### Annual Report 2001-2002

## **2001-2002 Annual Report Recommendations**

### **Introduction to Technical Report**

### Average total dissolved solids (TDS) concentrations AEMP Lakes, open water season, baseline and 2001

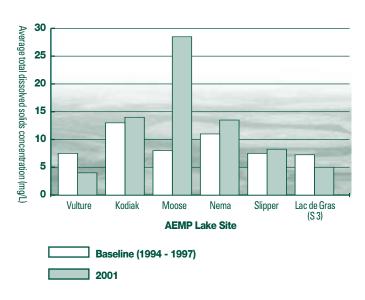
The Agency is becoming increasingly concerned with the rising concentrations of dissolved solids being discharged from the Long Lake containment facility into downstream waterbodies in the Koala watershed and, possibly, into Lac de Gras. This trend can be seen in Figure 3, where average concentrations of total dissolved solids are displayed. This distribution of values is typical of a situation in which there is a relatively concentrated source of contaminants that is moving downstream in a watershed. The highest average concentration is in Moose Lake, which receives waters from both Kodiak Lake and from Long Lake. The Long Lake containment facility is likely the main source of total dissolved solids. To date, however, the bay of Lac de Gras near Slipper outflow has yet to experience any significant changes for total dissolved solids. Although there is limited baseline information for Leslie Lake, the first lake downstream of the Long Lake containment facility, it has strategic importance as an early warning for downstream water quality changes in the Koala system and should be added to the aquatic effects monitoring program.

The predicted levels of major ions from Long Lake as reported by BHPB, are unlikely to be directly toxic to aquatic species. However, increasing dissolved salts in the naturally salt-poor waters of the area will likely lead to a change in the composition of sensitive and specialized aquatic communities that are highly tolerant of very low salinity. Significant increases in salinity could result in some of these highly sensitive and specialized local organisms being eliminated, as other more salt-tolerant species replace them. At the end of the project, dissolved solids concentrations will return to normal, and more disruption to the aquatic community will likely occur. Our reviewer, Dr. John Sprague, noted that special local varieties of organisms might be lost when this occurs at mine closure,

Figure 4. Long Lake containment facility BHP BILLITON DIAMONDS INC.

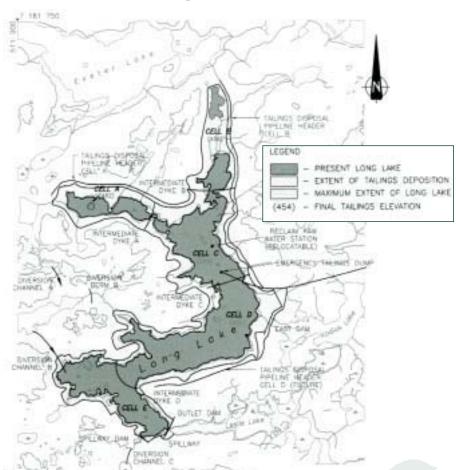
The first of a series of independent studies examining the toxic effects of processed kimberlite effluent on zooplankton has been completed by researchers at the University of Saskatchewan (thesis by Simone J. Crocquet de Rosemond). Initial results indicate that significant decreases in zooplankton abundance and diversity occurred in cells B & C of the Long Lake containment facility. These effects were not observed in cells D & E where no deposition of kimberlite has occurred. In contrast, water quality changes have been observed in all cells of the containment facility including cell E. The results also indicate that the processed kimberlite itself is not the cause of the toxicity but, rather, residual amounts of the artificial settling agents (flocculants and coagulants) used to settle the fine kimberlite particles in the water column appear to be the toxic agent. These results have led Environment Canada to initiate a supplementary study on environmental effects of these additives. One objective of the study is to develop techniques for the accurate analysis of coagulant and flocculant concentrations in the tailings discharge and to evaluate the persistence of these compounds in the environment. At this time, there is no evidence of these toxic effects downstream of the Long Lake containment facility, but they might occur (in Leslie Lake for example), as mining continues.

The second phase of the study will investigate whether a lake bottom covered with tailings (as is developing in cells B & C of Long Lake) will provide a viable physical and chemical environment for benthic organisms. This comprehensive multi-phase study involves water quality, sediment and benthic sampling and analysis throughout the operating life of the facility.

Figure 5. Ekati Diamond Mine™ including Sable, Pigeon and Beartooth.

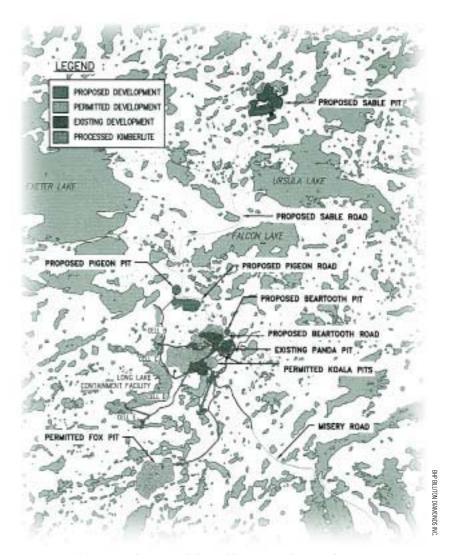
- 1. adequate investigation and design work for the proposed Pigeon diversion channel had not been conducted to assure the Board that upstream fish and aquatic resources would remain viable during operations and following closure of the Pigeon mine.
- 2. waste rock at the new pipes, particularly Pigeon, had not been properly sampled, so that no representative picture of the volumes of problem waste rock (potentially acid-generating biotite schist) was before the Board.
- 3. proposed mitigation measures for poor quality waste rock drainage (frozen waste rock dumps, frozen core toe-berms, and setbacks from lake edges) were all undemonstrated technology and, therefore, experimental with some degree of risk attached.

- 4. given the reasonable possibility of climate change in the future, and the warming of the tundra, the waste rock dumps should be designed for unfrozen conditions.
- 5. certain additional aquatic baseline data need to be collected prior to mining.
- 6. the Board should begin to consider the role greenhouse gas mitigation and compensation plans might play in the regulatory process.
- 7. construction and operation of the haul roads around the pits need careful attention to minimize the risk of impact to wildlife, particularly caribou and grizzly bear.
